# CITY OF ALBUQUERQUE

PLANNING DEPARTMENT – Development Review Services

RE: **Shoppes at Ellison (S. of La-Z-Boy)**  
**Drainage and Grading Plan | Engineer's Stamp Date 2-3-2016 (File: A14D010E)**

C1.1

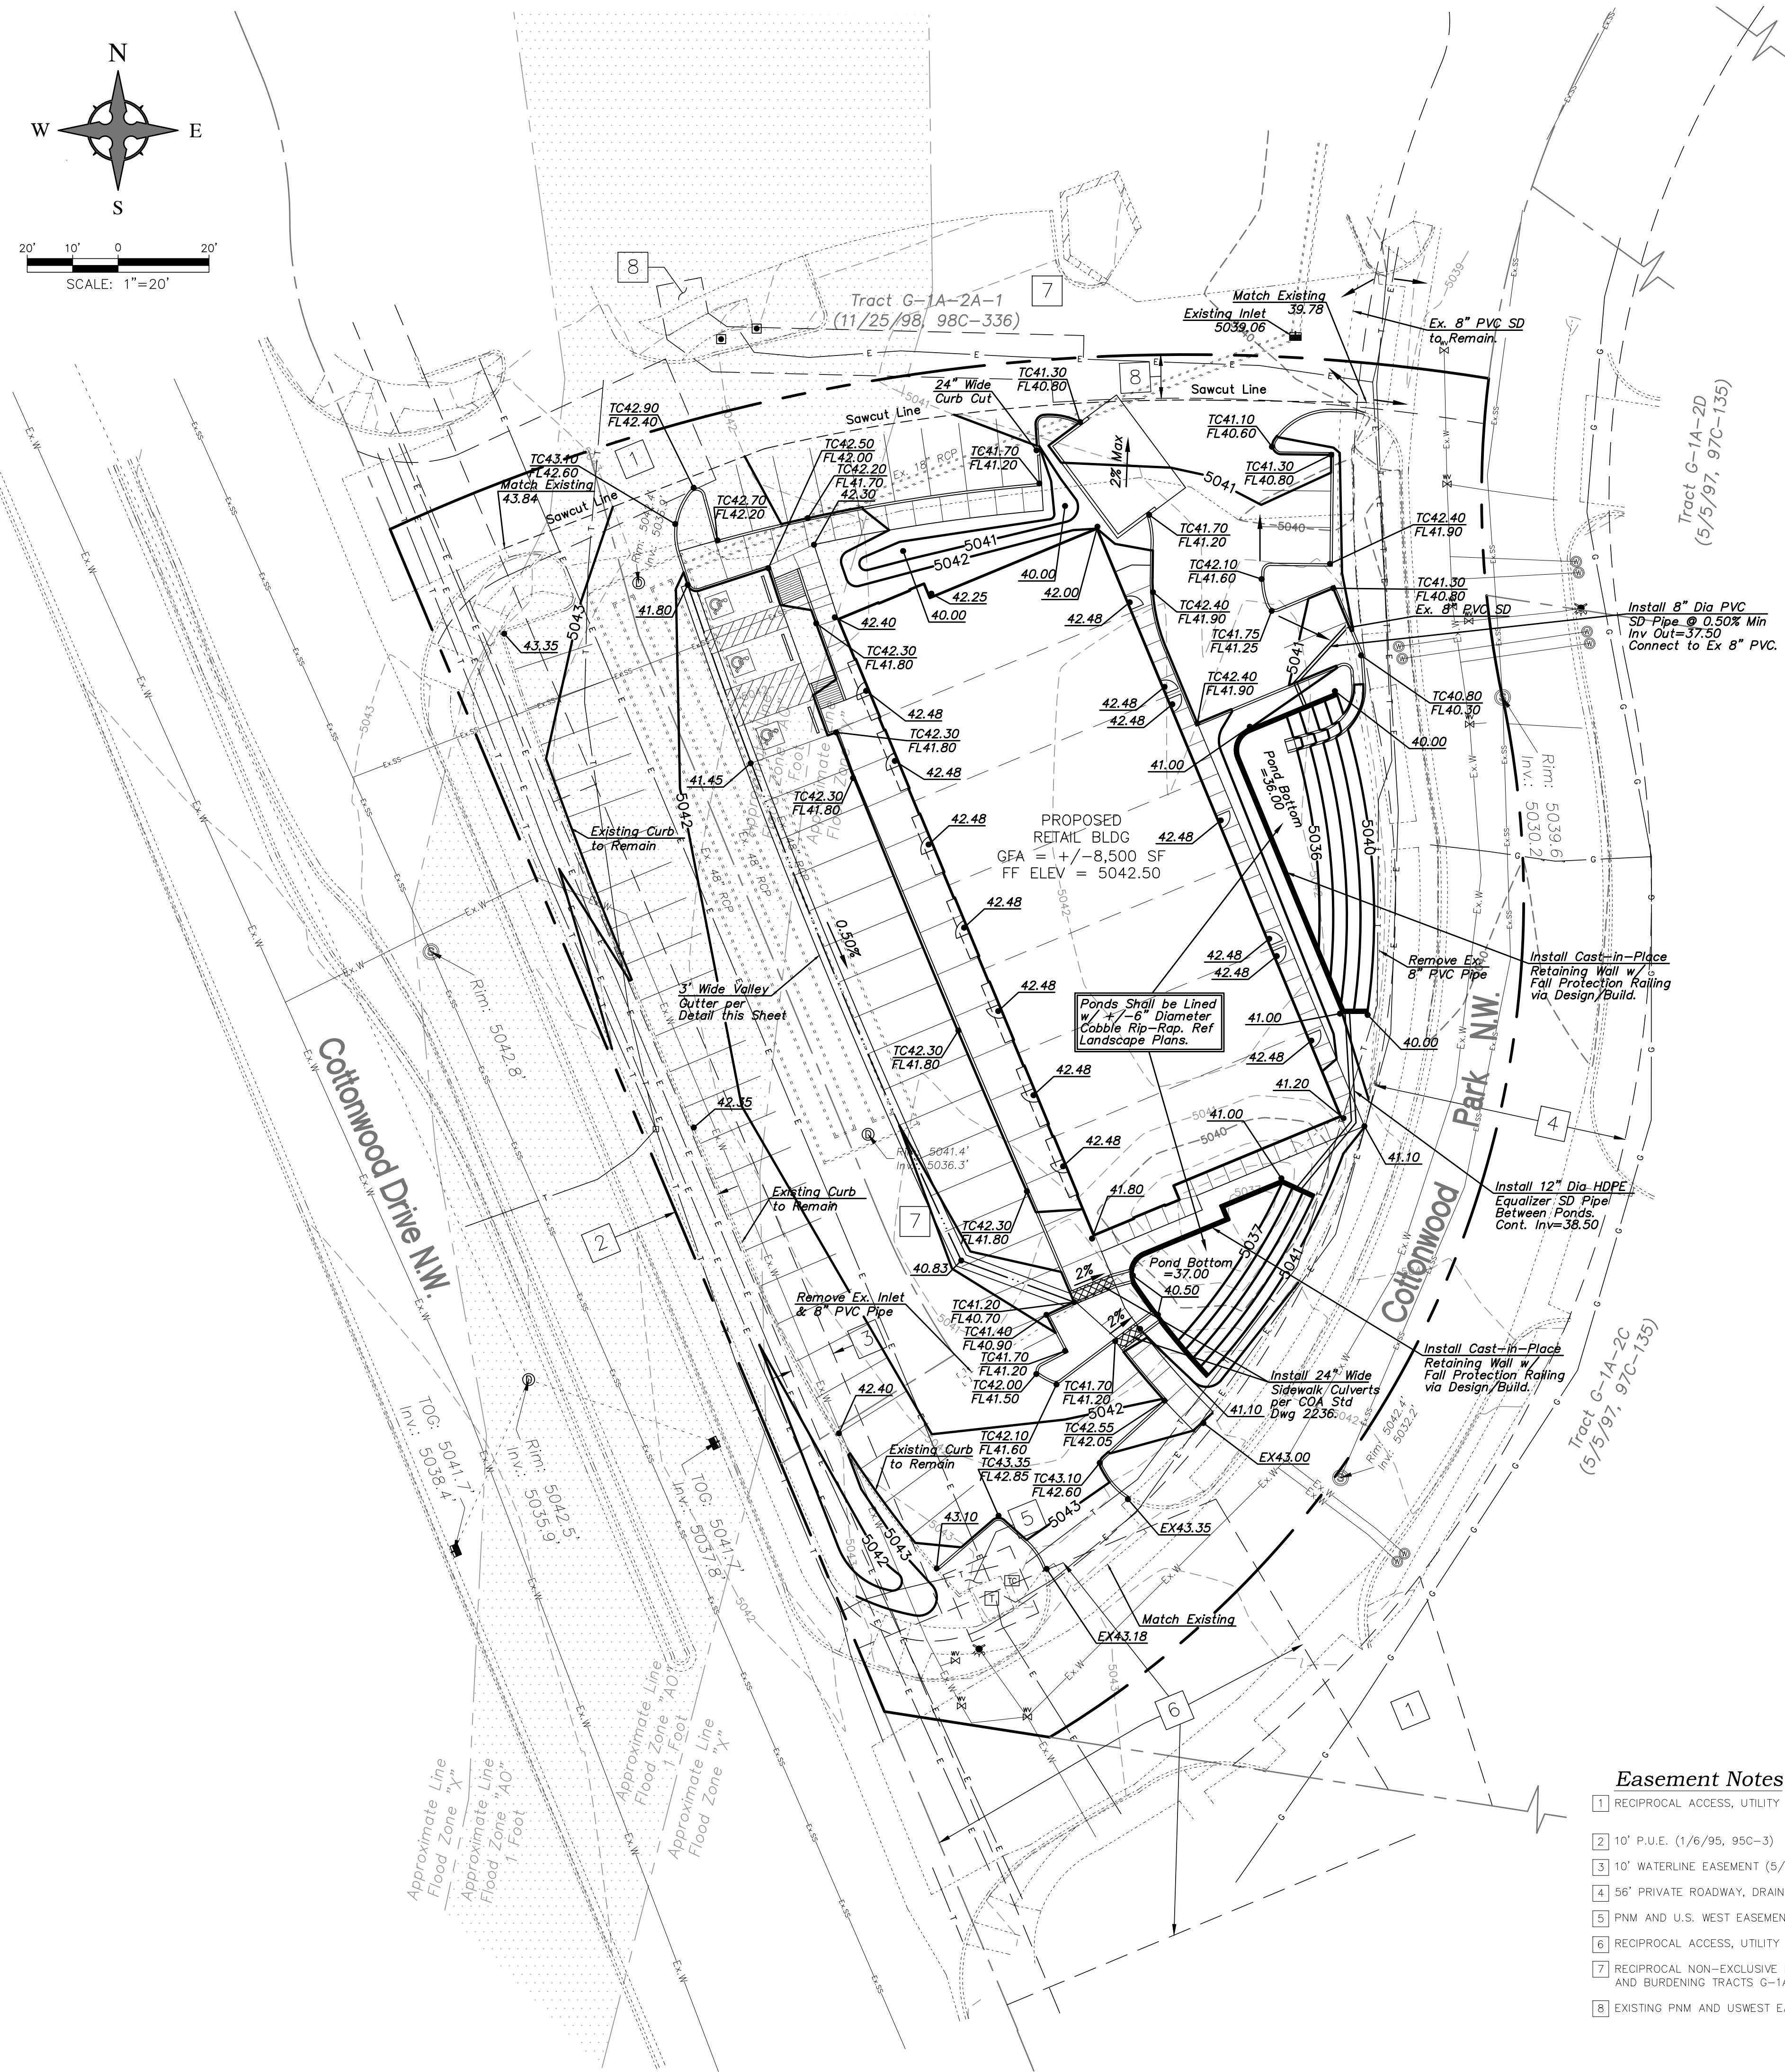
1. Provide invert elevations for the 8" equalizing within Ponds 'B' and 'C'.
2. The Drainage Report should show that the WSEL of Pond 'C' will not cause a head differential that would cause an overspill in the "La-Z-Boy" pond. The original site plan established the tops and bottoms of the two previous design iterations for this site, but it is unclear if this revised layout still complies with the Master Drainage Plan. Also, please provide excerpts and exhibits from that Master Plan, the City's file only contains poor-condition copies and scans of the correspondence for that site.

3. It appears that the buffer area between the back of sidewalk and the curb on Cottonwood Dr and Cottonwood Park will be landscaped. Please show the City's revised Standard Drawing for 2405A and 2405B to show the Landscape Buffer Swale.

4. Clarify how the sidewalk culverts in basin B drop into the pond.
5. The 8" PVC network appears to have several bends and a new connection to existing. It should be planned with cleanouts in the absence of manholes.

6. Show the intended flow direction of the roof on the plan, and location of roof drains if known. They should be routed under the sidewalk where possible.

7. The first flush calculations are shown on Sheet C1.2, but it is not yet clear how Ponds 'B' and 'C' will retain the required volume.
